Errata Sheet

Rel. 1.4, 12.11.2009

Device	**TC1167**
Marking/Step	**QS-AD**
Package	**PG-LQFP-176-5**

This Errata Sheet describes the deviations from the current user documentation.

Figure 1 Timing concerning equidistant multiple timers

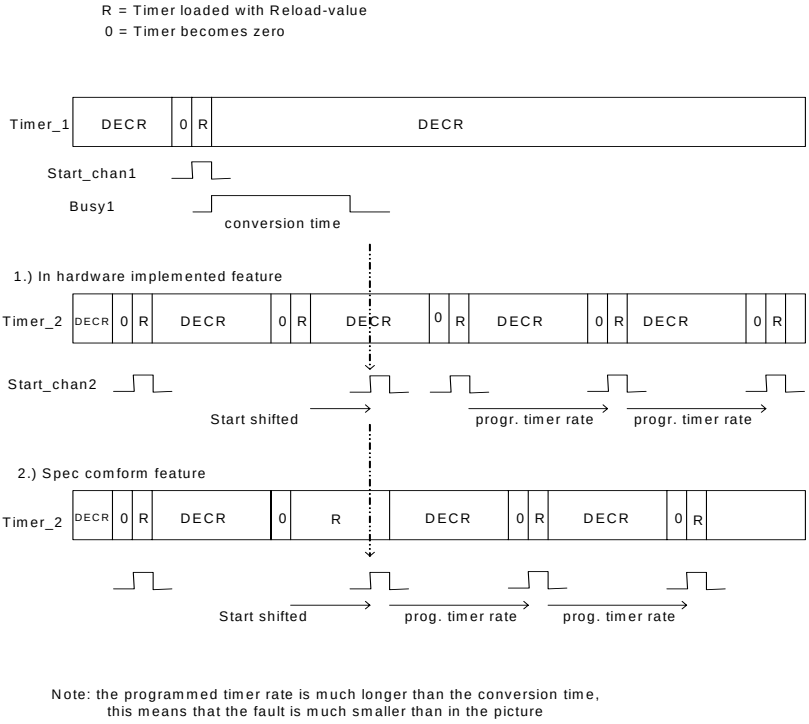
The correct behavior would be a reload when the requested conversion (of channel_2) is started.

Therefore the start of conversion for channel_2 is delayed by maximum one conversion-time. After this delay it will be continued with equidistant conversion-starts. Please refer to the following figure.

Note: the programmed timer rate is much longer than the conversion time, this means that the fault is much smaller than in the picture

Figure 2 Loss of Arbitration

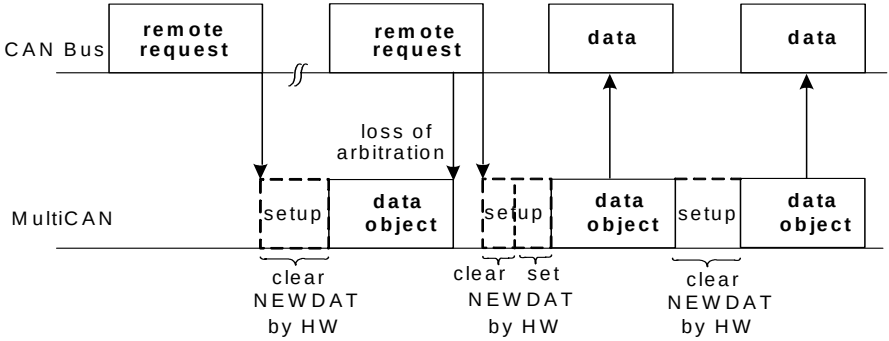
When the appropriate message object (data frame) triggered by the first remote frame wins the arbitration, it will be sent out and NEWDAT is not reset. This leads to an additional data frame, that will be sent by this message object (clearing NEWDAT).

There will, however, not be more data frames than there are corresponding remote requests.
